Landrover V8 Series III

Multi Alarm Engineering Change Instruction

Figure 1 — Low Water Sensor

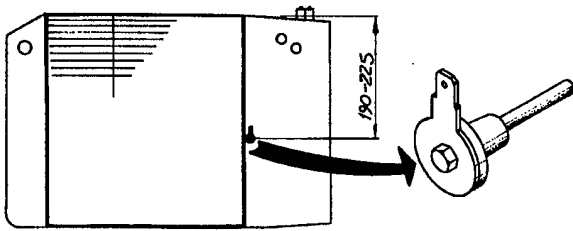
- a. Remove radiator and drill a 5/16" (8 mm) diameter hole in the header tank as shown in Fig 1.

Figure 2 — Centre Dash Panel

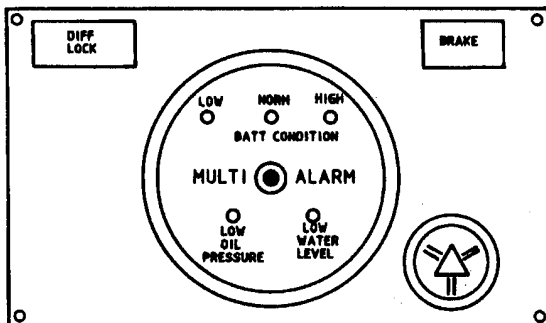
- b. Fit low water sensor, item 3, into radiator and tighten to achieve a water tight seal.
- c. Refit radiator and refill cooling system with coolant.
- d. Remove centre dash panel and remove hazard light from its mounting hole.
- e. With the 2½ inch hole saw enlarge the existing hazard switch hole to accommodate the display unit, as per Fig 2.

- f. Reposition hazard light switch as per Fig 2.
- g. Using electrical cables, items 4 to 9, manufacture a wiring harness as per Fig 3.

Figure 4 — Back of Centre Dash Panel

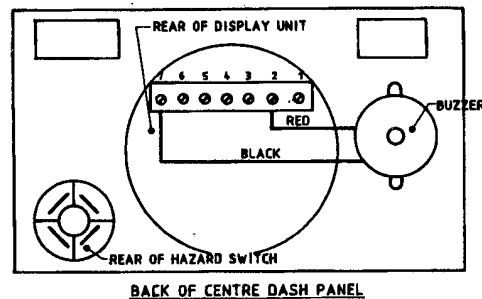
- h. Mount the buzzer, item 2, onto the back of the centre dash and connect wires as per Fig 4.

Figure 5 — Wiring Diagram

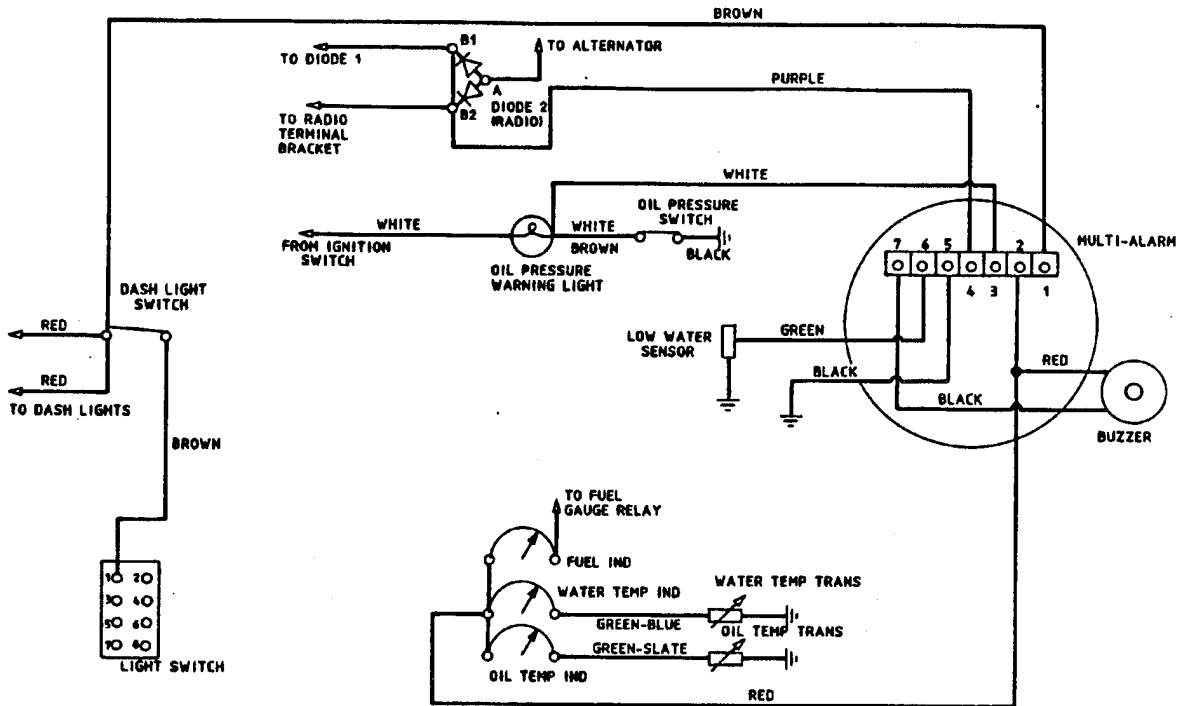
- i. With the harness manufactured at para 11 g. wire the components as per wiring diagram Fig 5, using the following procedure:

- (1) Wire harness to back of display unit and connect remaining ends to components as follows:
- (a) Green wire using terminal, item 12, to the low water sensor.
 - (b) Black wire using terminal, item 12, to earth.
 - (c) Purple wire using utilux terminal, item 11, to terminal B2 on radio battery blocking diode.
 - (d) Brown wire using connector, item 10, to switched side of dash lights.
 - (e) White using connector, item 10, to earth side of oil pressure warning light.
 - (f) Red wire using connector, item 10, to feed side of water temperature gauge.
